HISTORIC AND DESIGN REVIEW COMMISSION

December 21, 2022

HDRC CASE NO: 2022-574
ADDRESS: 145 NAVARRO ST
LEGAL DESCRIPTION: NCB 986 LOT 11 THRU 13 AND E 5.14FT OF 10
ZONING: D, H, RIO-3
CITY COUNCIL DIST.: 1
APPLICANT: Peter Ketter/Sandvick Architects Inc.
OWNER: Kunal Mody/145 NAVARRO LLC
TYPE OF WORK: Construction of a rooftop addition, fenestration modifications, window replacement, rehabilitation, canopy installation and signage
APPLICATION RECEIVED: December 02, 2022
60-DAY REVIEW: Not applicable due to City Council Emergency Orders
CASE MANAGER: Edward Hall
REQUEST:

Proposed Exterior Alterations
HDRC Conceptual Review – December 2022

Roof Floor Plan

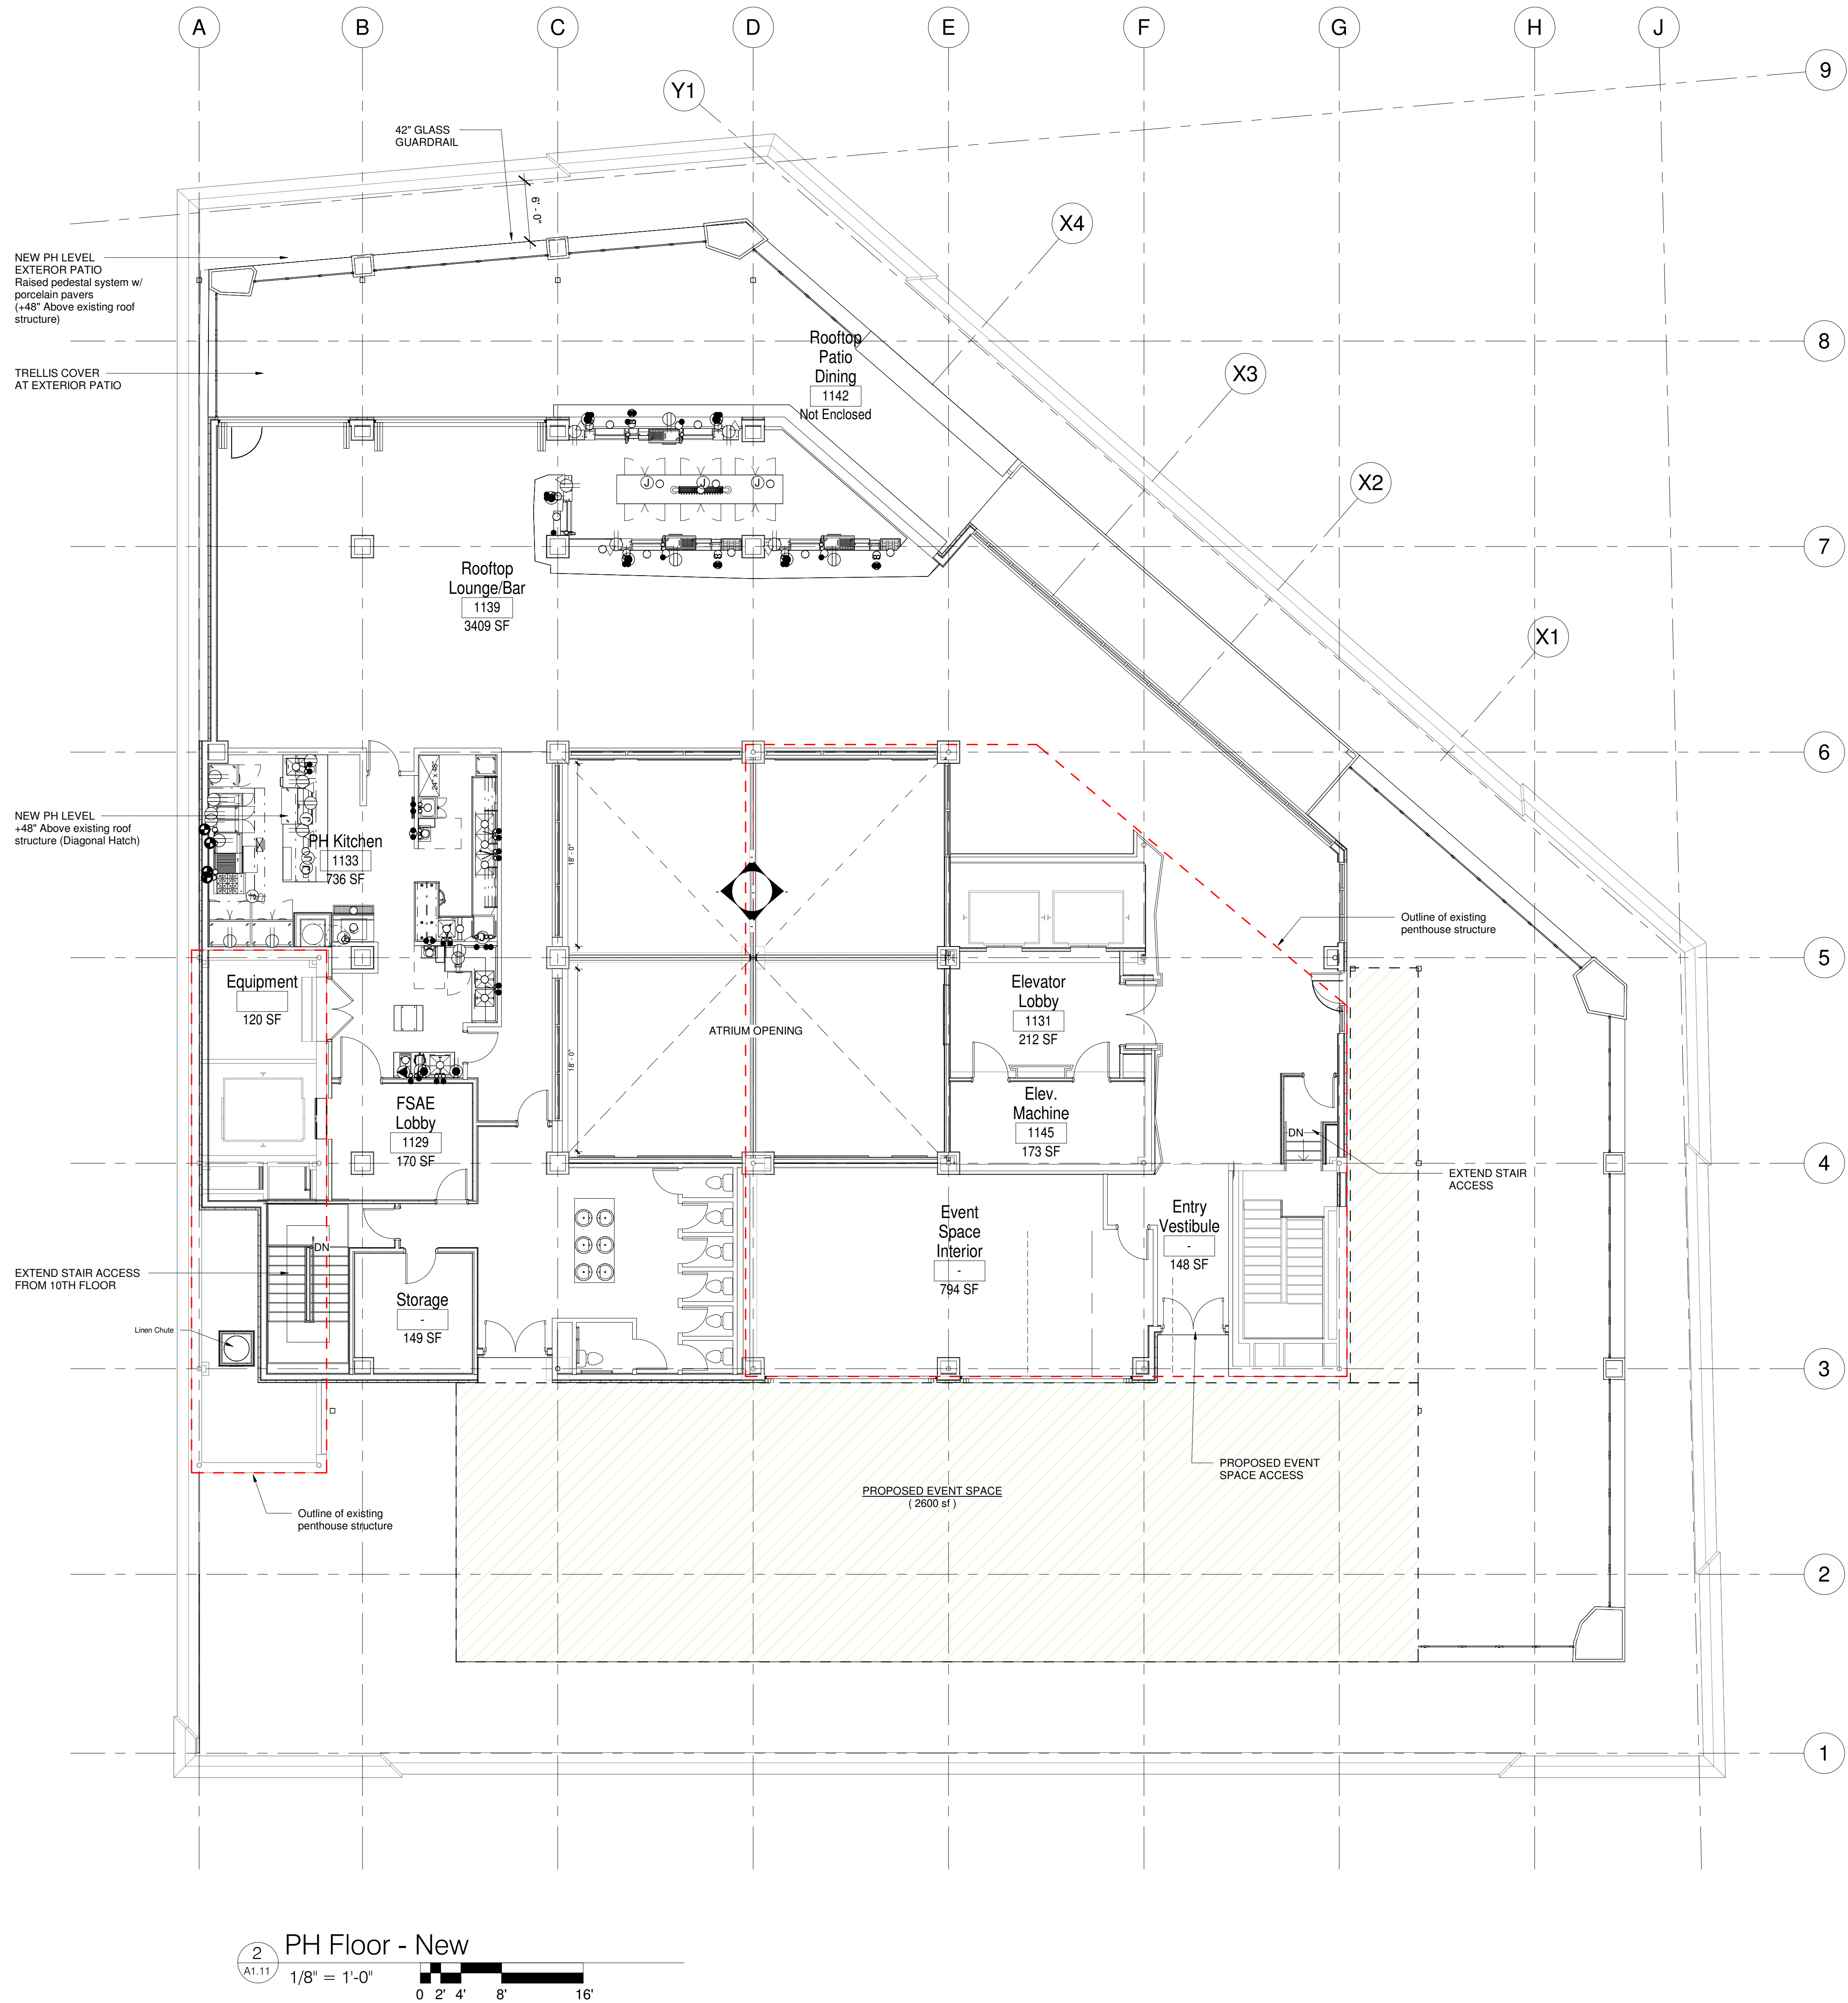
- h. **SKYLIGHT** – The applicant has proposed to create a roof skylight opening to create an interior atrium. Staff finds the proposed skylight installation to be appropriate as it will not impact any exterior elements that are visible from the right of way.

- i. That storefront system frames and their components feature dark colors.
6. Staff recommends approval of item #6, the installation of a skylight, based on finding h, as submitted.
